Subject: Follow up on Donlin Technical Working Group meetings, December 2016

Re: Donlin Technical Meeting on Mine Water and Tailings Storage Facility

Re: Follow up on Donlin Technical Working Group meetings, December 2016

**Figure 3.5-28 of DEIS.** Flows (blue numbers) are in gallons per minute (gpm) expected in Years 52-200 of closure. Red arrows denote pumping routes; however, the route for “seepage” from the WRF will be a mix of gravity flow and pumping and perhaps should be marked with a red arrow.

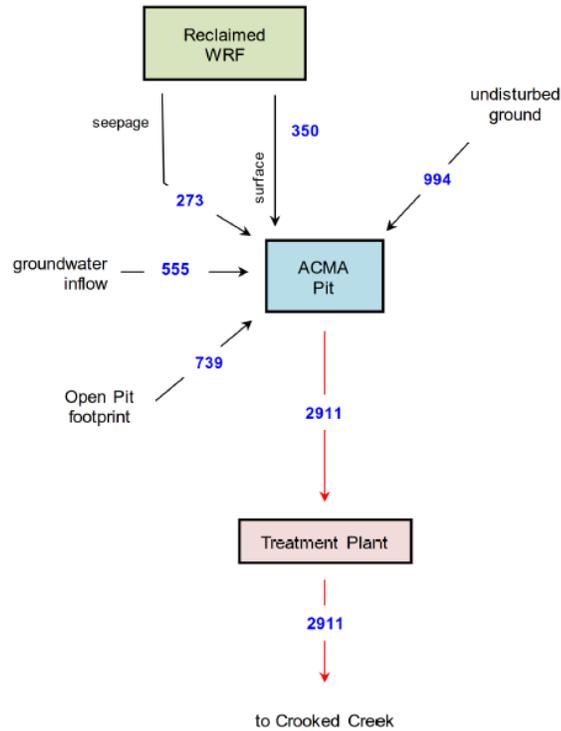
While there is an alternative to assess for tailings options, there is no alternative that eliminates the pit lake. It is a certainty. The only permanent inputs into the pit lake are the waste rock facility (WRF) seepage and clean runoff water/precipitation (Figure 3.6-9). The tailings facility (TSF) is expected to stop contributing after the 30-60 year draindown period.<sup>1</sup> Groundwater may move into the pit in quantity (Fig. 3.5-28), but there is currently a lack of data supporting the conceptual model describing over 500 gpm groundwater flowing into the pit and no groundwater flowing out.

<sup>1</sup> There is expected to be about 400 gpm clean groundwater flow (Fig. 3.5-28 and p 3.6-38, DEIS) to dilute the 18 gpm allowed to seep through the TSF liner, and therefore any water that infiltrates and percolates through the TSF cover is not expected to be poor quality.

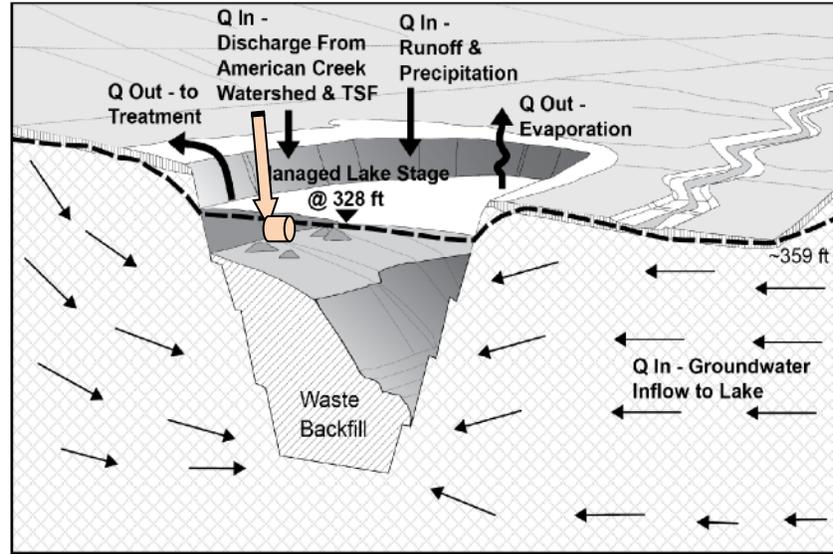
Waste rock seepage – very high in total dissolved solids, arsenic, and other contaminants, will enter a rock drain under the WRF and flow towards the pit. At the pit rim, it will be pumped to the bottom of the pit; presumably it will be pumped to the depth immediately above the waste rock backfill, rather than 1,800 feet down to the actual pit bottom. Freshwater inputs will float on this saline seepage water; this

stratification is a key part of the mine “design for closure” and a key argument to why the WRF should not be lined or provided with an impermeable cover.

This is insufficient. The bad water on the bottom of the pit lake *will* eventually mix throughout the lake. The effect of this mixture on wildlife, and inputs that contribute to mixed lake water quality need to be assessed. Cooperating agencies should not trivialize this issue simply because it may not occur for 100-200 years after closure. While the mining company will be long gone, the people and wildlife will remain and fewer mitigation options may be available.

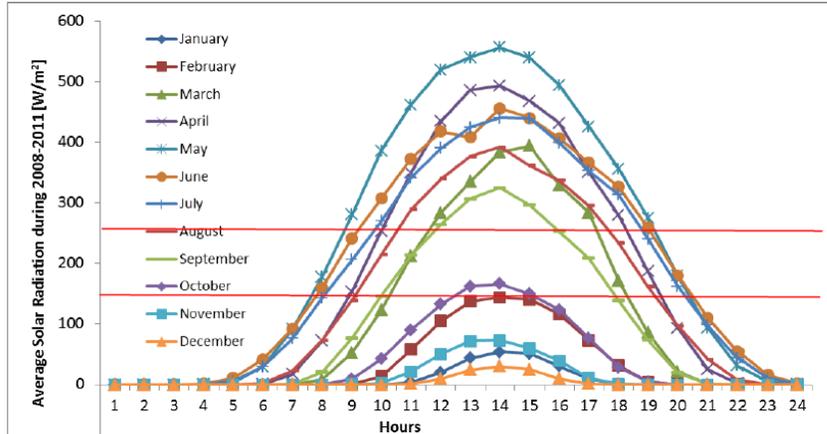
Solar radiation on site is expected to be low 72% of the time, middle range 8% of the time, and high 20% of the time (Environ 2014c, Figure 3-5 and pgs 20-21) (bars added to separate low, medium, and high solar radiation levels).

Although the Donlin area receives a range of solar radiation, only “low” and “middle” radiation were used to calculate fugitive gas emissions.

The difference between the fugitive gas emissions that could be released under low and high radiation for the tailings facility are striking (Environ 2014c, Table 3-4 above).

- RFAI: Adjust the fugitive gas emissions model to account for the percent of time with high solar radiation.
